Work Order ID 84540

Item Name: 205 Skidtube bent detail

DRAWING NO. D2580	TITLE 205 SKIDTUBE ASSEMBLY	REV. E	<b>DART AEROSPACE LTD ENGINEERING ORDER</b>	D.E.O. NO. D2580-E-1	SHEET NO. SHEET 1 OF 1	SCALE NTS
DRAWN <i>UP</i>	CHECKED <i>ASS</i>	MFG. APPR. <i>ER</i>	APPROVED <i>#</i>	DE APPR. <i>#</i>		
DATE 11.12.13	DATE 11.12.13	DATE 11.12.13	DATE 11.12.13	DATE 11.12.13

CHANGE ALL C'BORED WELDED CROSSBOLT SPACERS TO SWAGED SPACERS

**SECTION B-B, F-F, I-I**  
NOT TO SCALE

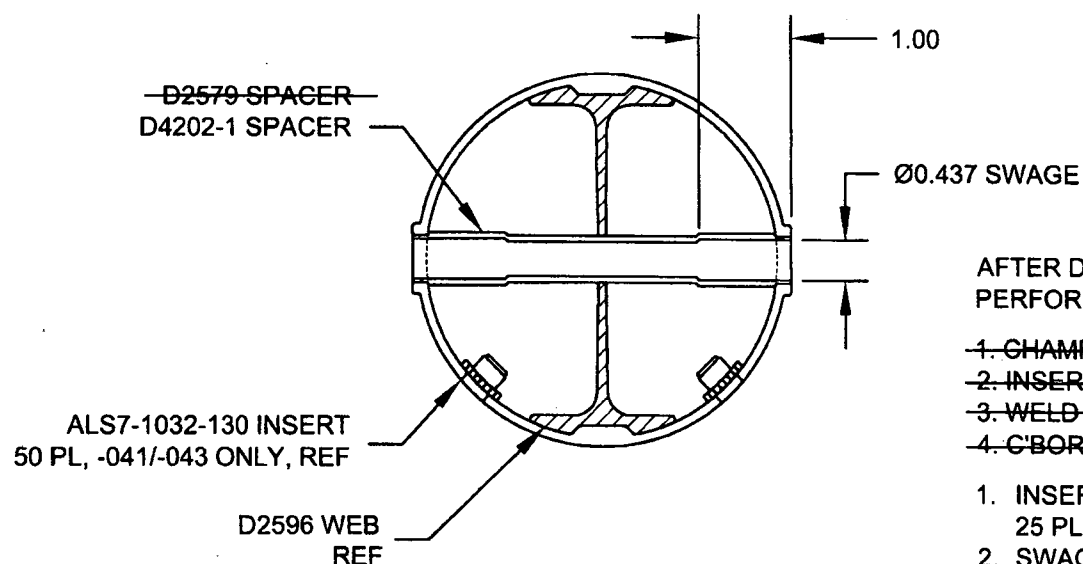
PARTS LIST IS AMENDED AS FOLLOWS:

QTY	QTY	QTY	PART NUMBER	DESCRIPTION
-041	-045	-047		
20	24	25	D2579	CROSS BOLT SPACER

4		* D2579	CROSS BOLT SPACER
20	20	25	D4202-1	SPACER

SECTION B-B, SECTION F-F, & SECTION I-I ARE AMENDED AS FOLLOWS  
FOR ALL HOLES THAT WERE ORIGINALLY C'BORED:

**\* FOR -045 SKIDTUBE ONLY:**  
WELD 4X D2579 SPACERS PER DWG  
IN LOCATIONS MARKED "NO C'BORE".  
REF SHEET 4 OF DWG.

AFTER DRILLING AND BENDING ASSEMBLY  
PERFORM THE FOLLOWING FOR Ø0.508 HOLES ONLY:

1. CHAMFER HOLE 0.050 X 45°
2. INSERT D2579 SPACER (20 PLACES)
3. WELD INTO PLACE AND GRIND FLUSH
4. C'BORE D2579 SPACER TO Ø0.437 X 1.00 DEEP

1. INSERT D4202-1 SPACER, 20 PL (-041) OR 20 PL (-045) OR 25 PL (-047)
2. SWAGE TO Ø0.437 X 1.00 DEEP PER QSI 002
3. TRIM / GRIND FLUSH PER QSI 002
